RE: 833 Dolores Dr. NW
Grading and Drainage Plan
Engineer's Stamp Date: 01/17/20
Engineer's Certification Date: 12/24/19
Hydrology File: J11D040

DRAINAGE AND TRANSPORTATION INFORMATION SHEET (REV 6/2018)

RE: 833 Dolores Dr. NW
Grading and Drainage Plan
Engineer's Stamp Date: 12/13/19
Hydrology File: J11D040

ENGINEER'S SEAL	833 DOLORES DR.	DRAWN BY DEM
DAVID SOULE NEW MEXICO REGISTERED PROFESSIONAL ENGINEER 12/24/19	GRADING AND DRAINAGE PLAN	DATE 12-12-19
	Rio Grande Engineering 1608 CENTRAL AVENUE SE SUITE 201 ALBUQUERQUE, NM 87106 (505) 972-0899	833 DOLORES.DWG
		SHEET # C1
		JOB #

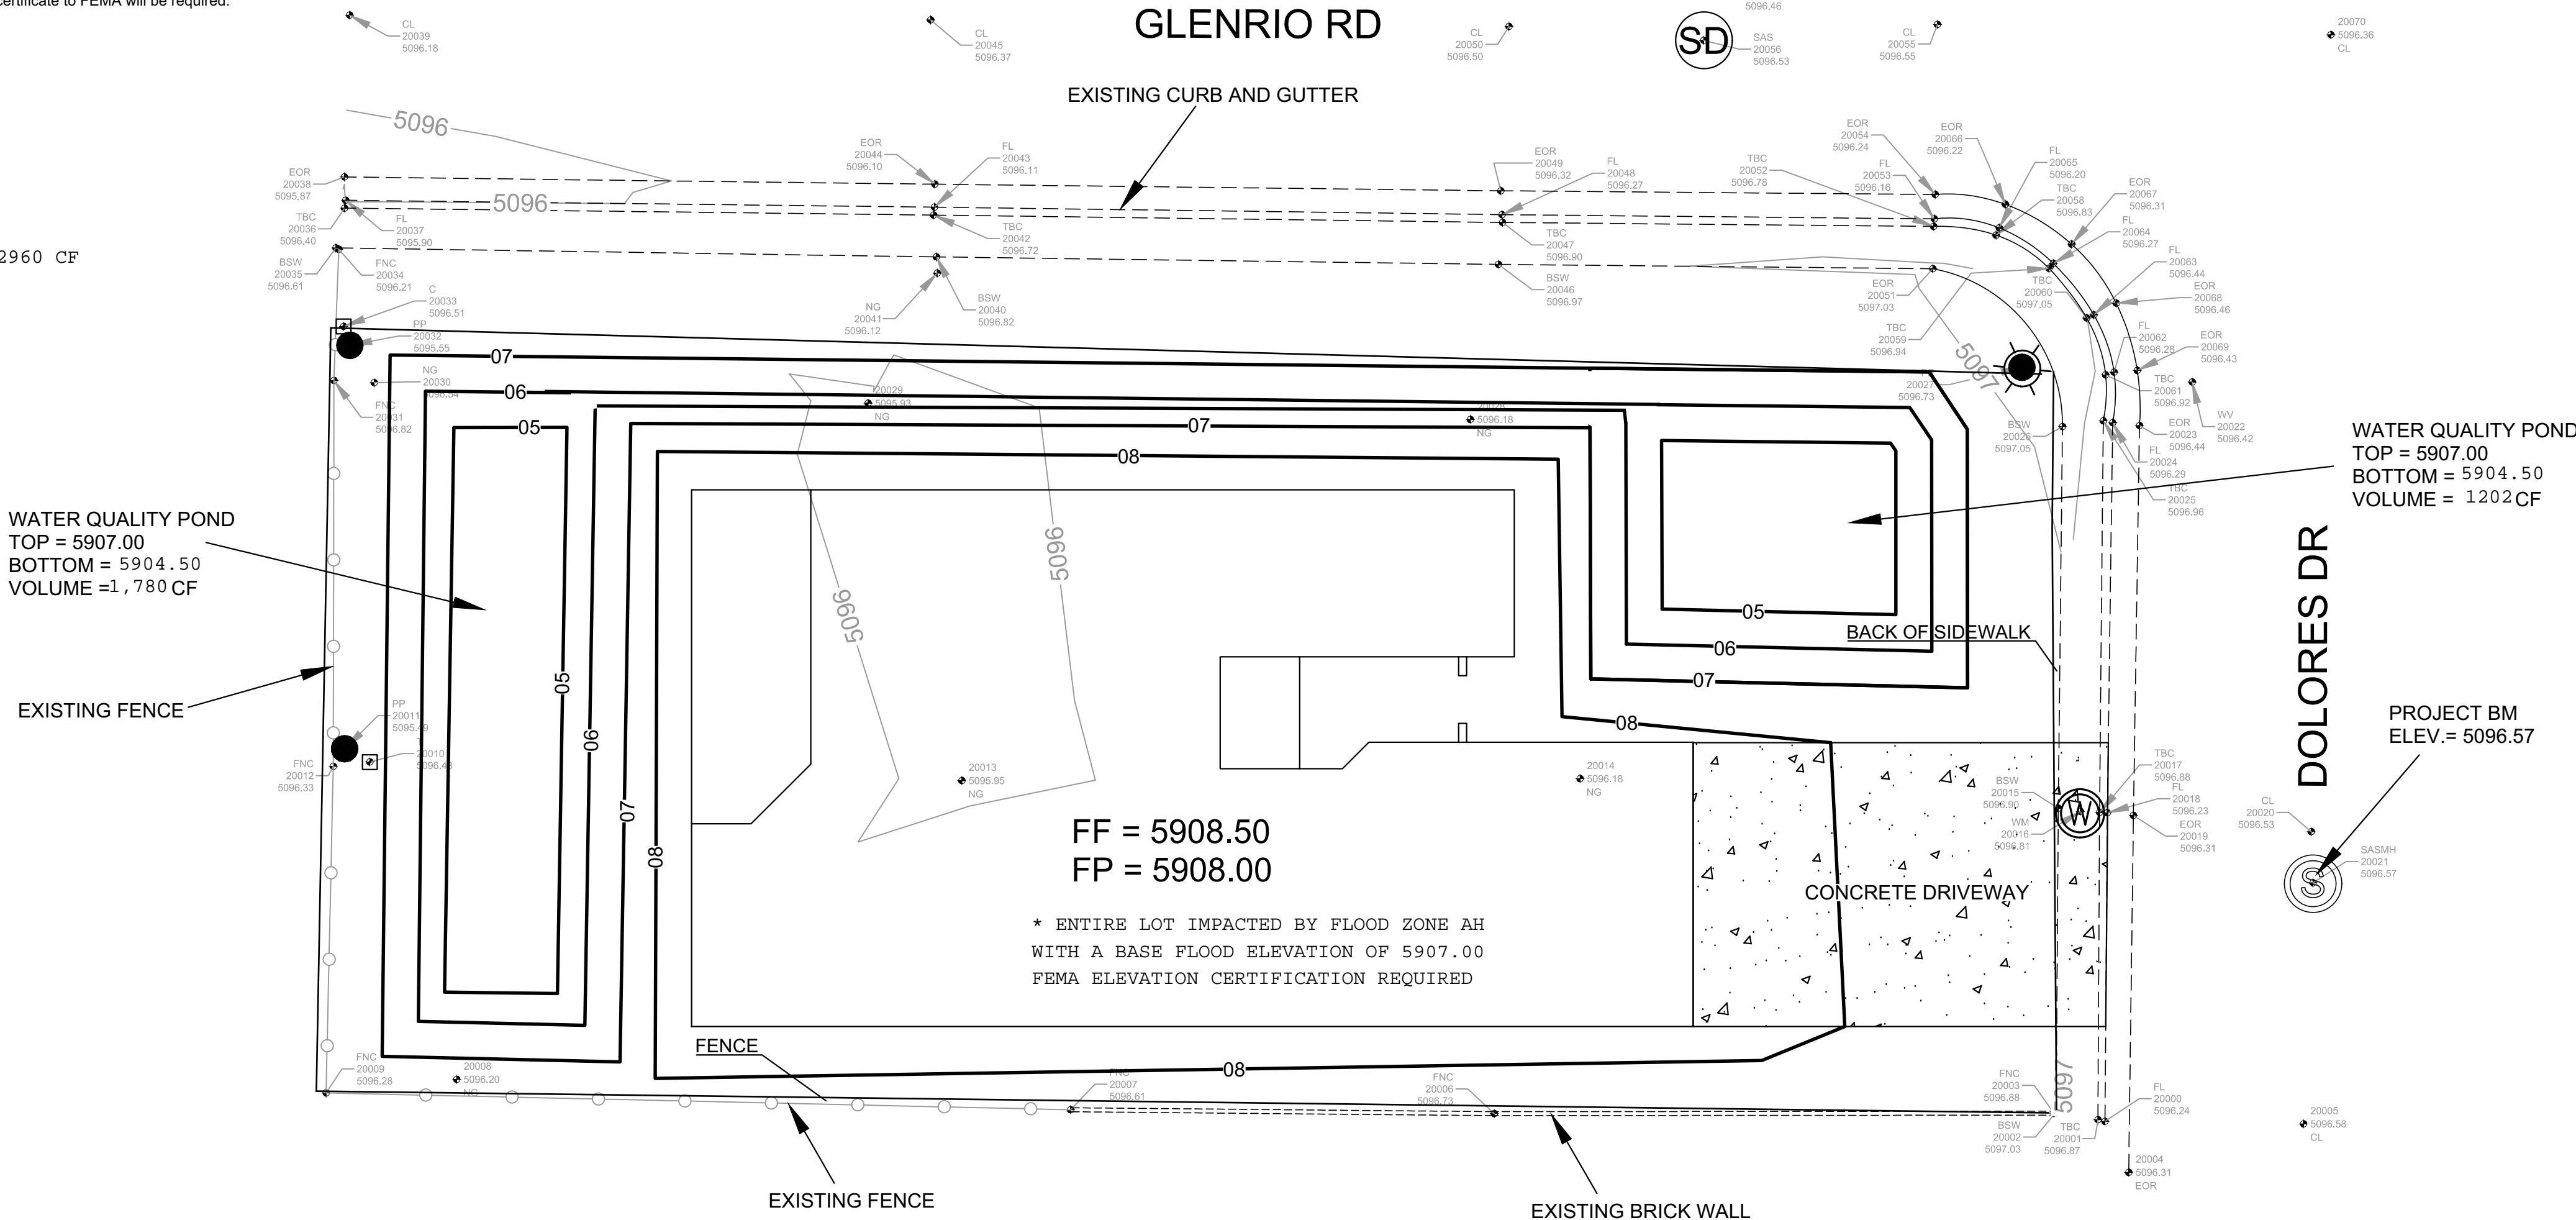
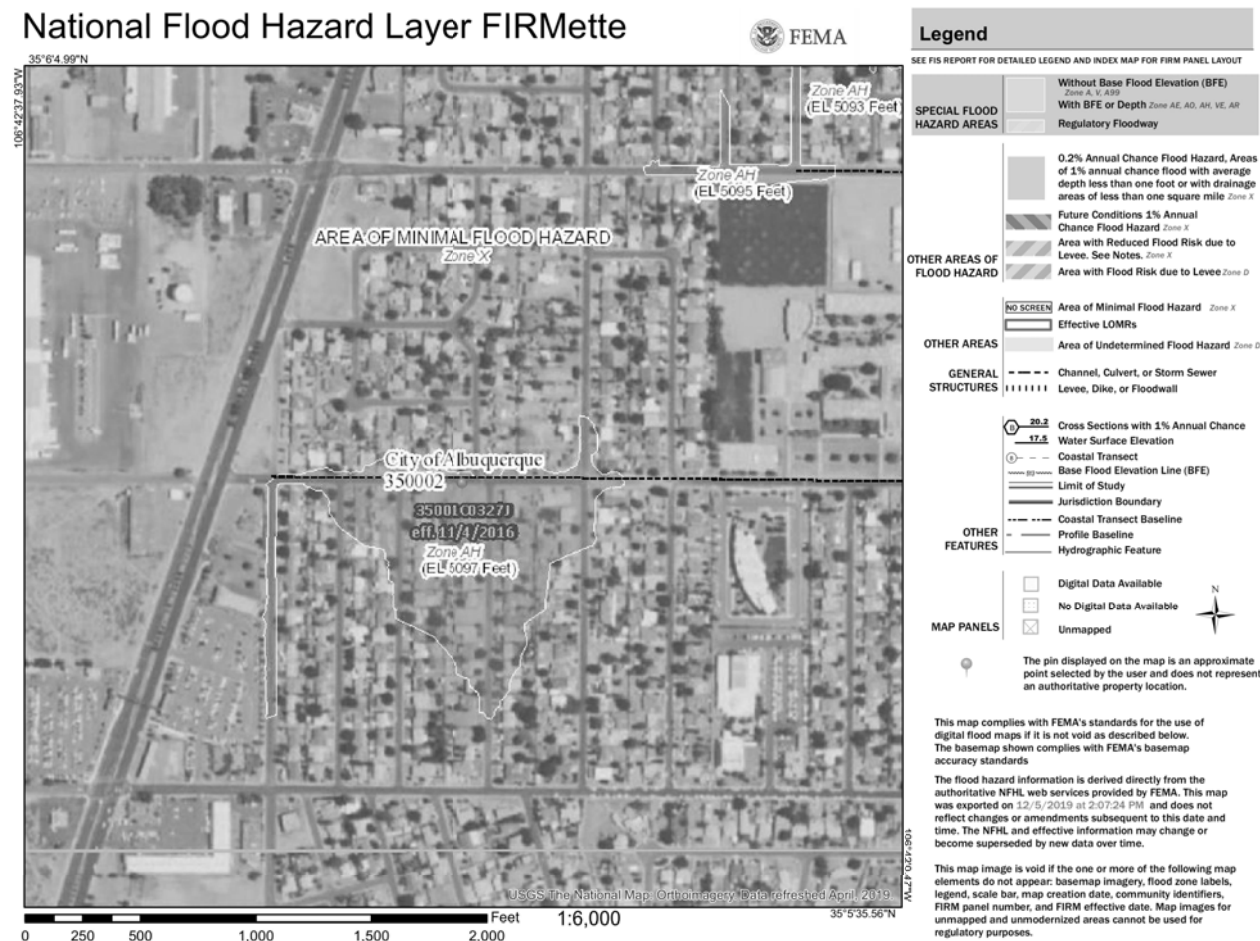
Based upon the information provided in your submittal received 12/13/2019, the Grading and Drainage Plan **is not** approved for Building Permit. The following comments need to be addressed for approval of the above referenced project:

1. As stated on the plans, this site is located in a floodplain (AH – Elev 5907) and must have a floodplain development permit prior to issuing the Building Permit. The permit application must demonstrate zero rise to the base flood elevation, unless a Letter of Map Revision (LOMR) is being prepared. Please contact Rudy Rael, CFM for more information regarding floodplain development permits (rrael@cabq.gov or 924-3977).
2. Since this needs only needs a floodplain development permit, an administration fee of \$40 will be required at the time of resubmittal.

This site is within a fully developed area of albuquerque. The site lies within flood zone AH. The base flood elevation is 5907 msl. The site currently does not drain. The proposed development will set the finished pad (highest adjacent grade) at 5908, which is 1 foot above the flood plain. The site will retain the entire flow generated by the lot. The lot will fill the the flood plain elevation and enter the roadway and adjacent flood plain in the 100 year event. A flood plain permit and elevation certificate to FEMA will be required.

FLOOD PLAIN VOLUME FILLED
AVG ELEV=5906.38
THEREFORE VOLUME= .62 X 4741=2960 CF
VOLUME PROVIDED=2982 CF
